AL/5/18/RES

PLAN-021704

Proposal: Approval of reserved matters following outline consent AL/75/14/OUT for 2 No. dwellings
Site: Woodgate Farm, Westergate Street, Westergate, PO20 3SS.
AL/5/18/RES

ARUN DISTRICT COUNCIL AL/5/18/RES

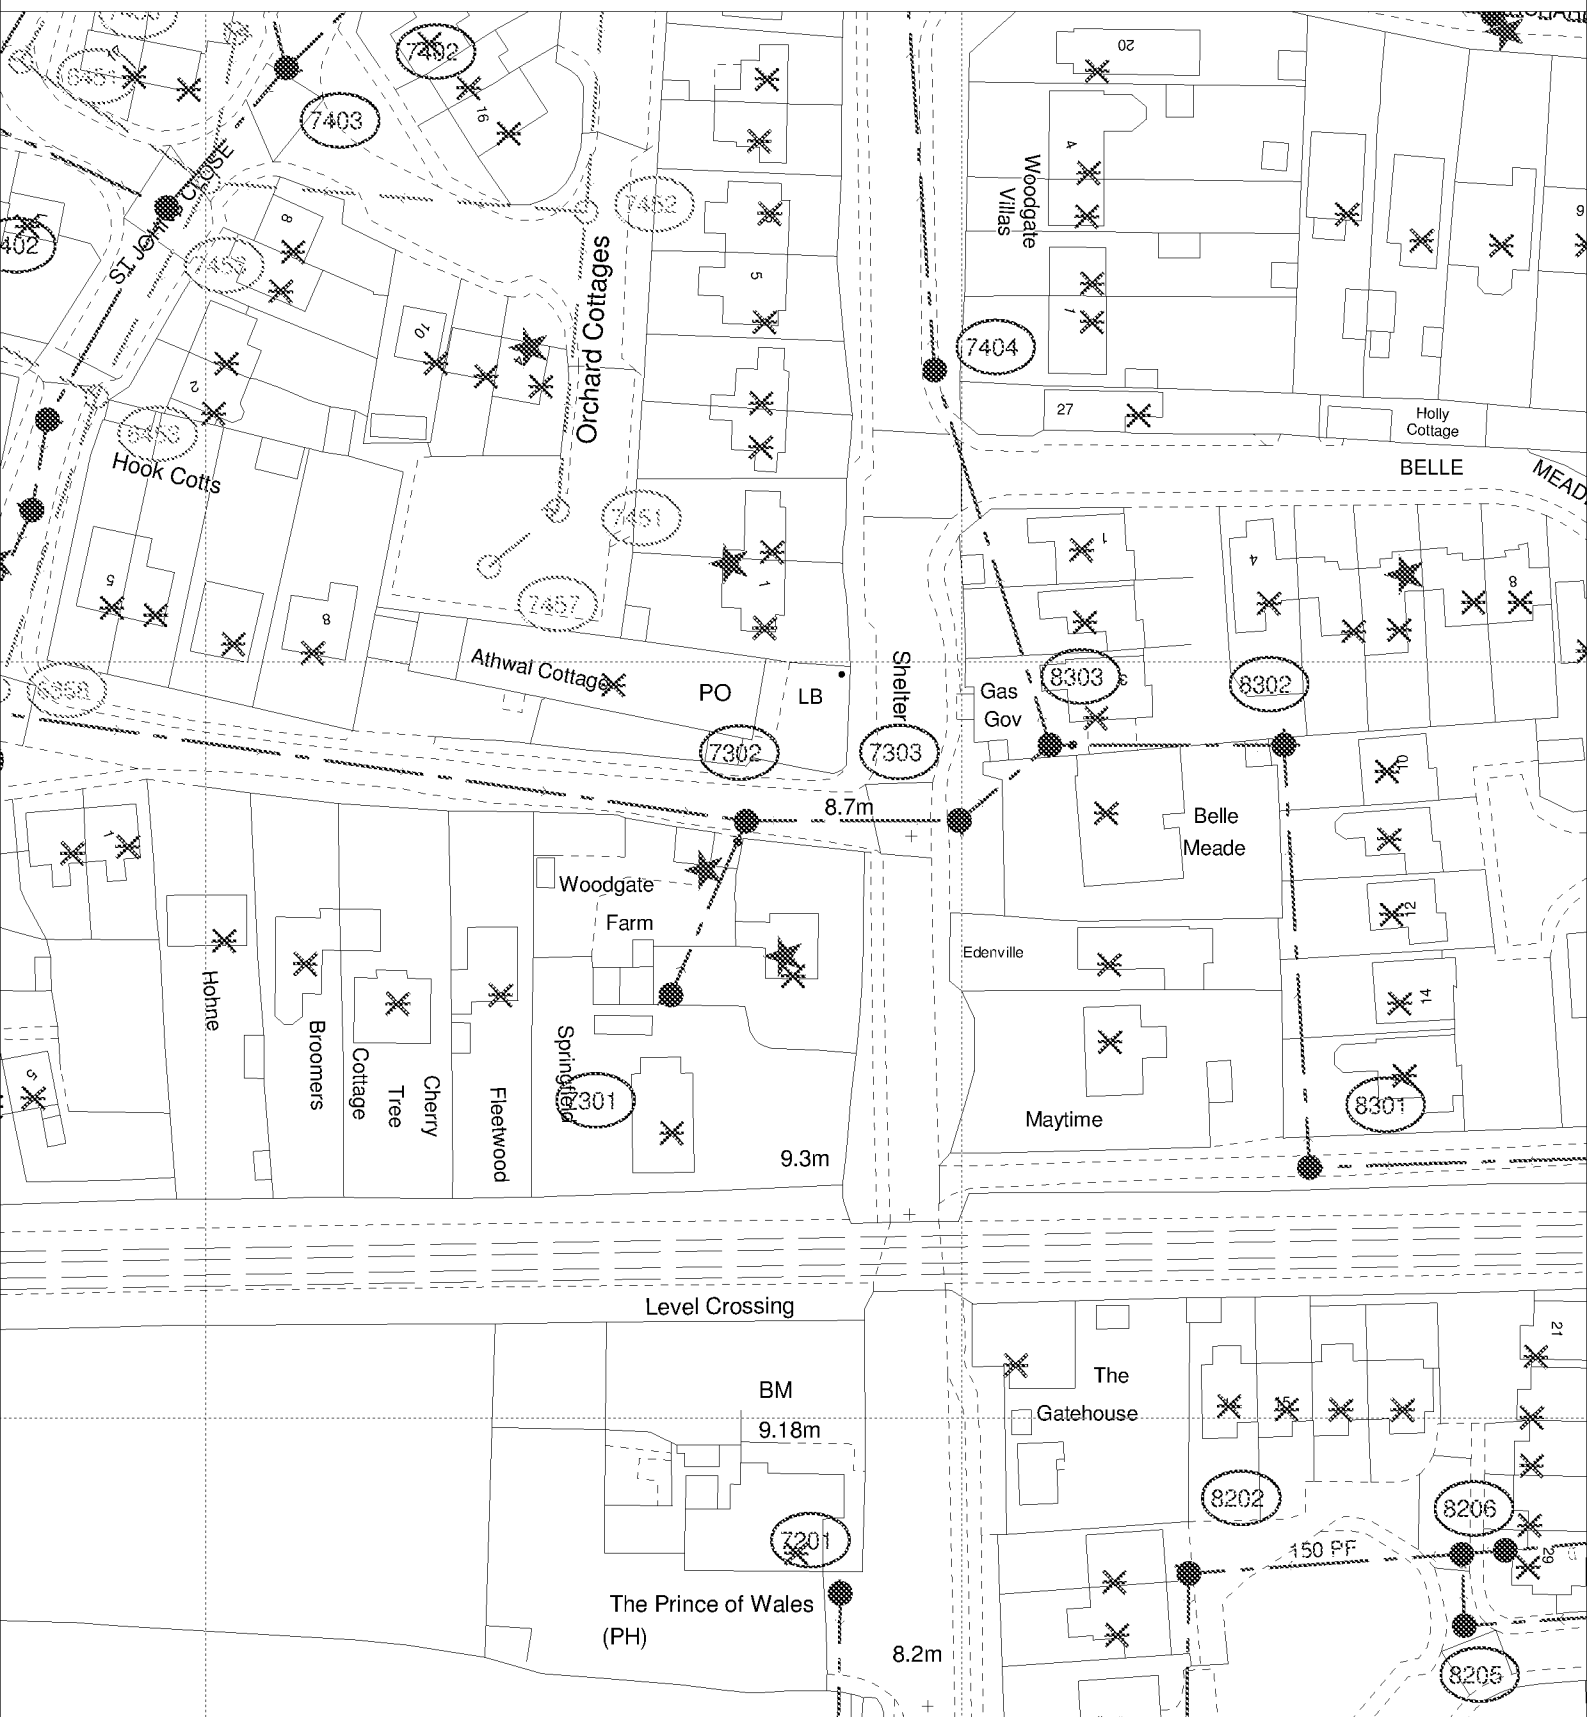
The construction of permeable paving over public or adoptable sewers will not be acceptable. The design of drainage should ensure that no land drainage or groundwater is to enter public sewers network.

No new soakaways, swales, ponds, watercourses or any other surface water retaining or conveying features should be located within 5 metres of a public sewers.
